# MOBILITY ADVISORY COMMITTEE MEETING MINUTES

Thursday, December 12, 2024, 1:00 PM

**Project Name:** OR99W: Corridor Safety & Intersection Improvements (Roundabout) – K23457

**Project Name:** South Madras Concept Area Refinement Plan

*Figure 2: Conceptual Drawing of Proposed Roundabout*

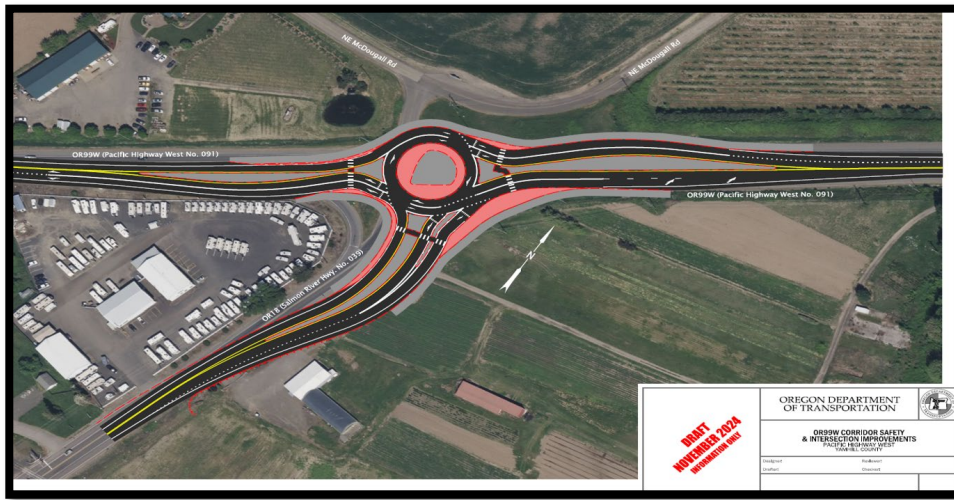
**Mark Gibson** (Oregon Trucking Association) offered the following comments:

- It would be nice if the design of the roundabout could be modified so that oversize loads would not need to block traffic to make the turning movements discussed in the presentation
- It would be great if the Region could take a look at the Oregon State University/ODOT Roundabout study that is officially out now

**Kristine Kennedy** expanded on Mark's comment, stating that when they shut down roundabouts like this, its not just traffic control that is involved. They are usually too long to run at night, so they either have to obtain special permission to travel at night or take the load through during the day. If the roundabout does not have a bypass to go around it, they have to travel at night due to the high traffic counts during the day. This involves a lot of logistics in addition to traffic control, such as the need take into account the driver's hours and breaks when it comes to nighttime travel. She also asked how wide the lanes would be once the roundabout is constructed.

Paul responded by saying that they will take a look at the design and see if there is anything they can do to improve some of those movements.

**Cesar Lopez** responded by stating that the approaches will use the minimum of 16-feet wide coming into the roundabout and get wider as you come into the splitter islands.

The Region will return to the MAC at a later date to present an updated design with actual truck turning movements showing where the wheels are tracking.

Figure 4: Original & Updated Highway Cross-Sections\_US26 Junction – K Street (MP 92.08-93.15)

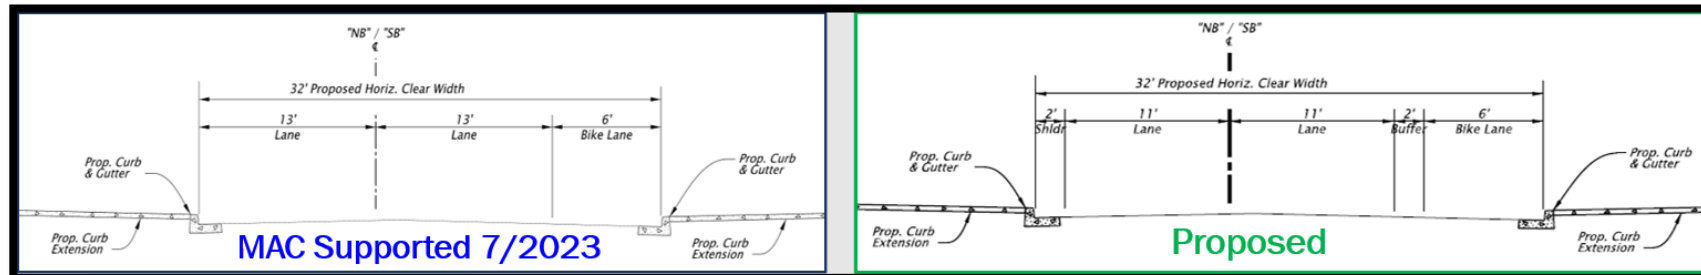
**Kristine Kennedy** noted that 12-foot wide lanes are really important to them (freight industry) for their safety, and pointed out the in the cross sections that Mark referred to, there are 6-foot wide bike lanes proposed with a 2-foot buffer. She suggested that we could narrow the proposed bike lane width to 5-feet through that section.

Mark responded by directing Kristine to the previous highway cross sections (existing & proposed) at MP 92.08 – MP 93.15, where the highway is more constrained due to the parking areas on either side of the highway. He added that we can probably get to 12-foot lanes at the bridge but would not be able to get there in the other locations, and they are trying to keep the striping consistent throughout.

*Figure 5: Existing & Proposed Highway Cross Sections US97 (4<sup>th</sup> Street) at the Bridge (Maple St – Pine St) MP 92.08 – MP 92.15*

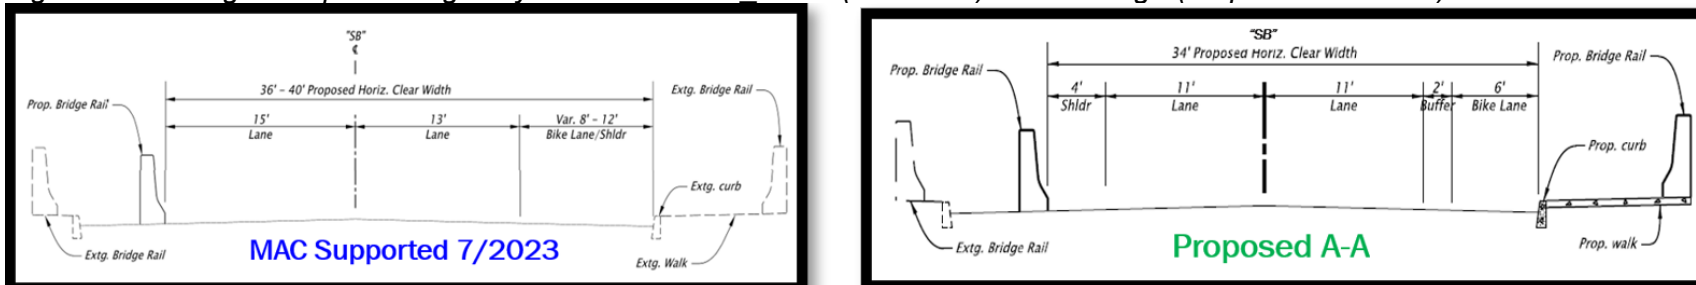
**Kristine Kennedy** (Highway Heavy Hauling) asked if there was any way to increase the proposed travel lane widths from 11-feet to 12-feet, and if not, what the reason is behind not being able to get to 12-feet.

**Kristine Kennedy** commented that we have had situations before where there was a 5-foot bike lane when there was a 2-foot buffer (which was confirmed by Katie Scott and Mark Barrett). She continued by saying that if we have a 5-foot bike lane with a 2-foot buffer, that will give us 1-foot and if we can reduce the shoulder to 3-feet and shift, that would get us to 12-foot lanes. She added that most of the equipment they haul is 11-feet 11-inches wide.

**Mark Gibson** (Oregon Trucking Association) suggested a compromise of one 12-foot wide travel lane and one 11-foot wide travel lane all the way through the corridor. He noted that US97 is a dedicated freight route and a Critical Route Pair with 23.5% truck traffic.

Mark responded by saying that their desire, carried over from the BUD, is to provide a buffer space between the bike lane and the travel lane. At this specific location (bridge) there is probably a little bit of room to get to the 12-foot lanes, however, for the northbound couplet and the couplet south of this location to be able to provide the buffer space, width has to be taken from somewhere and the travel lane is the only spot they can take it from without having to pursue a design exception. So, that is what the team has proposed.

Mark Barrett thanked everyone for chiming in. He said that they have certainly heard from the freight side, that there is a desire to get 12-foot lanes and that maybe a reasonable balance is to get one 12-foot lane. He has also heard from the bike/ped perspective, that there is a desire to keep the 6-feet of space for the bicyclist. He offered that what they can do as a team is to certainly take a look at this and see if there is space to get to a compromise between the two and bring that back when they have an answer.

Figure 2: (Example) Existing and Proposed Highway Cross Section\_ Baker Street (99W) at NE 4th Street

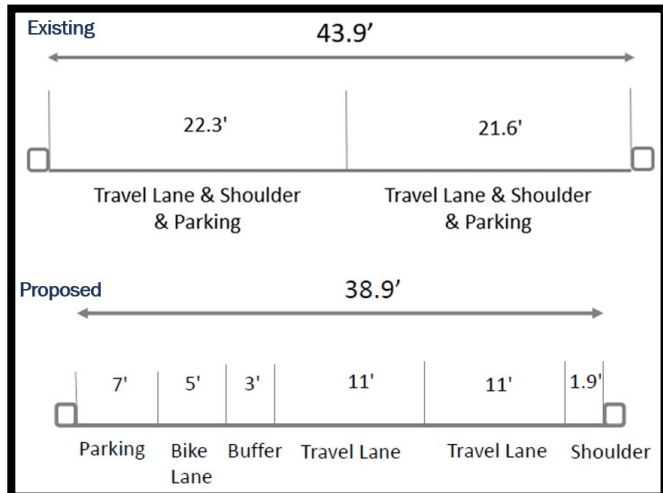
*“A change was made following the December 2024 presentation. The team was able to redesign one corner (OR99W/Baker St. and SE Lincoln St.), which results in there not being a bulb-out at this location.”*

Based on this design change, the information presented (and supported) at the corner of OR99W/Baker Street and SE Lincoln Street will not be included in the Record of Support, as there will not be a permanent Reduction of Vehicle-Carrying Capacity at that location.

Figure 3: Available horizontal clearance on OR99W at 15<sup>th</sup> Street during non-work hours

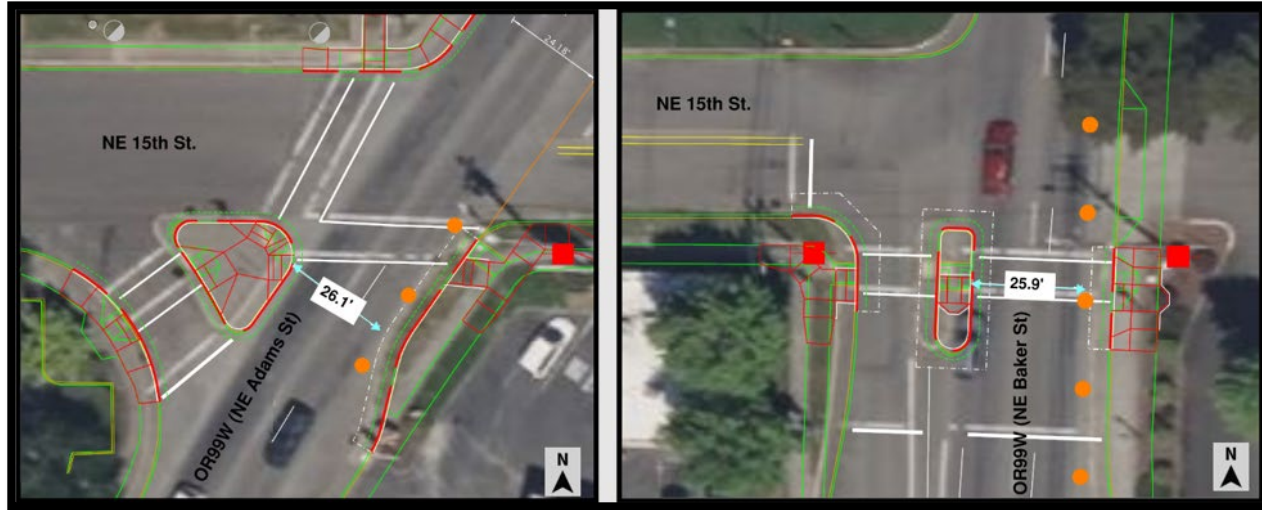
**Christy Jordan** (Mobility Program Manager) commented that anything less than 28-feet for two lanes of traffic is considered a restriction, according to the Mobility Procedures Manual. However, there are no hard rules to this, as it depends on the location, speeds, and how narrow the available width is. She said that in the past, they have involved the District Office, as they are the ones who set the pilot car requirements for super-loads. She added that the Stakeholders can definitely weigh-in on whether or not they feel safe or not if there isn't going to be a restriction, but usually what is done is we talk to the District Office and suggest what restriction is needed to keep things safe.

**Christy Jordan** commented that projects like this do not come up that often, where they have less than 28-feet and they are harder to deal with than just having a single lane restriction. She doesn't recall not having some sort of mitigation for widths that start getting below 26-feet. She added that the District Office is the road authority and that if they are comfortable having 14-foot wide loads traveling through without a restriction, it is surprising to her.
